Quality Control Check Report. Stage: After Finishing Stage III (Apartments)

Quality Control Check Report. Stage: After Plumbing & Electrical (Apartments)

GULMOHAR RESIDENCY

Details of Additions & Alterations

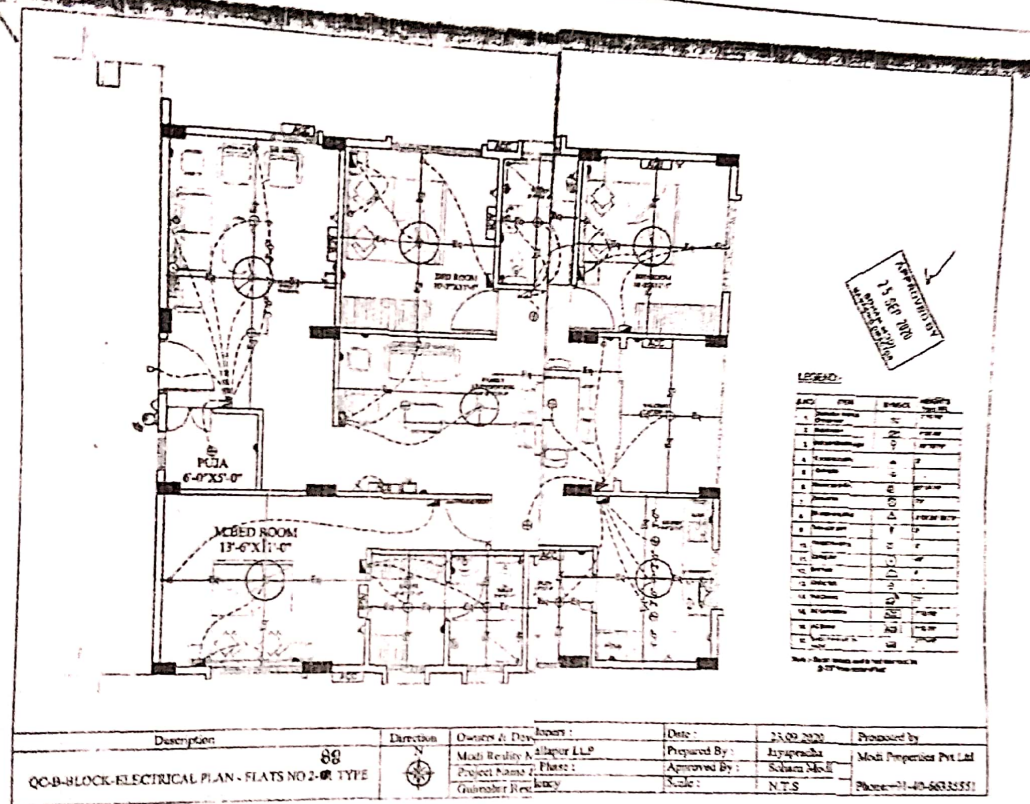
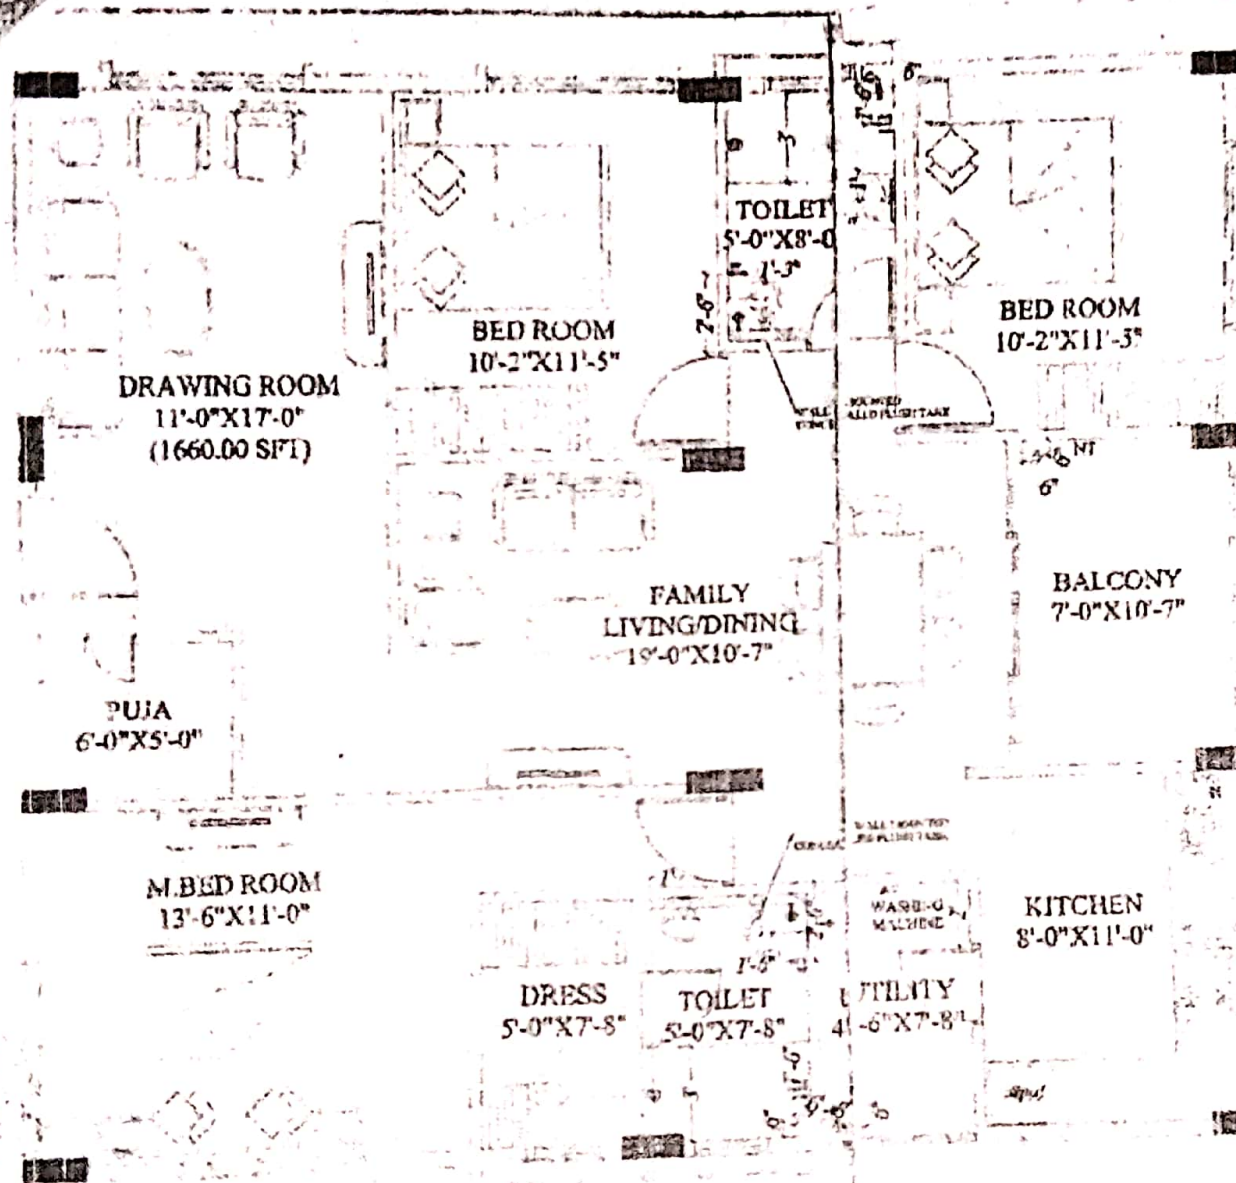
Remarks NOTE:- 1) level marking was not done. (2) In C.Toi, Shower Angle cock was placed at [6'3"] instead of [6'6"].

Remarks on additions & alteration sheet:

Description		Direction		Owners & Developers :		Project Name & Phase :		Approved By :		Soham Modi		Modi Properties Pvt Ltd	
WORKING PLAN-1660 SR-B1 TYPE		N		Modi Realty Mallapur LLP		Modi Realty Mallapur LLP		Prepared By :		Jayaprada		Promoted by	
								Date :		25.09.2020

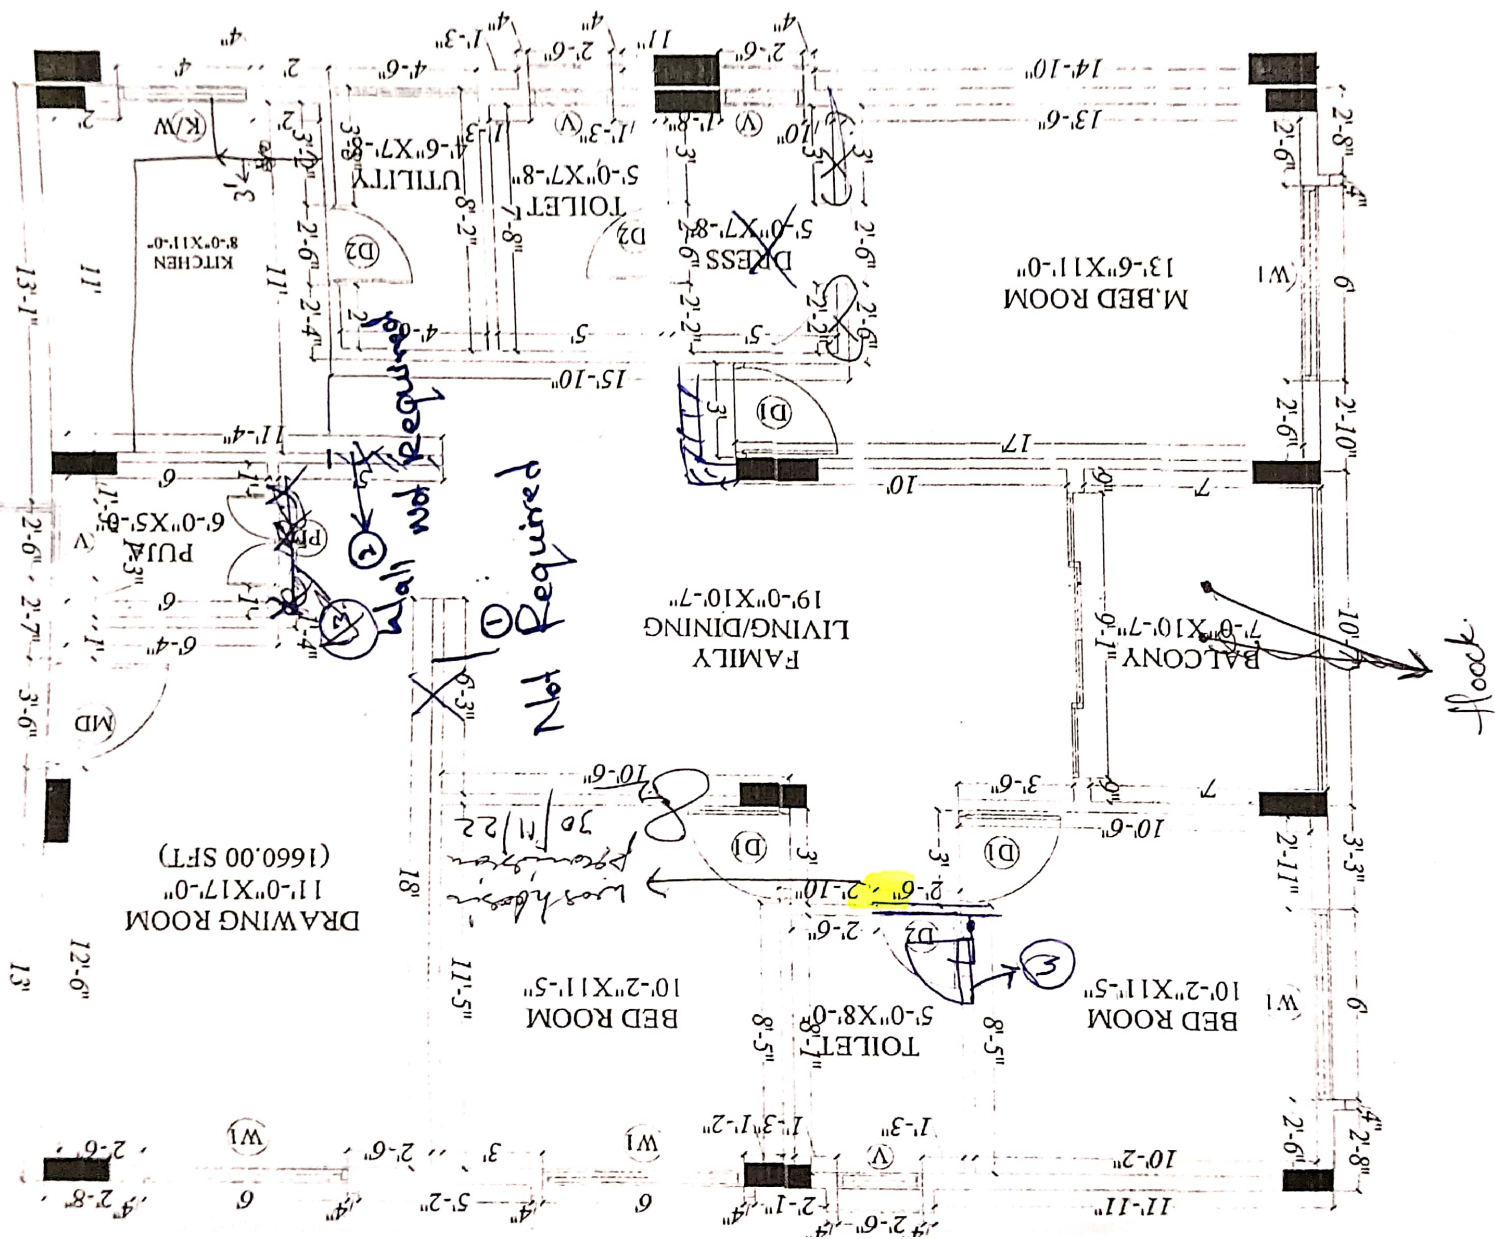
① Modular kitchen by customer

1) 6'3" wall has to be removed.

② (Pillar wall has to be removed as mentioned in drawing) Remain as same as original Plan don't remove wall.

③ Piller door frame of wall not required.

④ shift wash room door to left side wall from children's R.R. as shown in plan

⑤ Extra wash basin as Common Bathroom

⑥ Kitchen wash area should be flat.

⑦ m.b window has to closed beside wash room.

⑧ Between a children's bed room wash basin has to fix. Plg
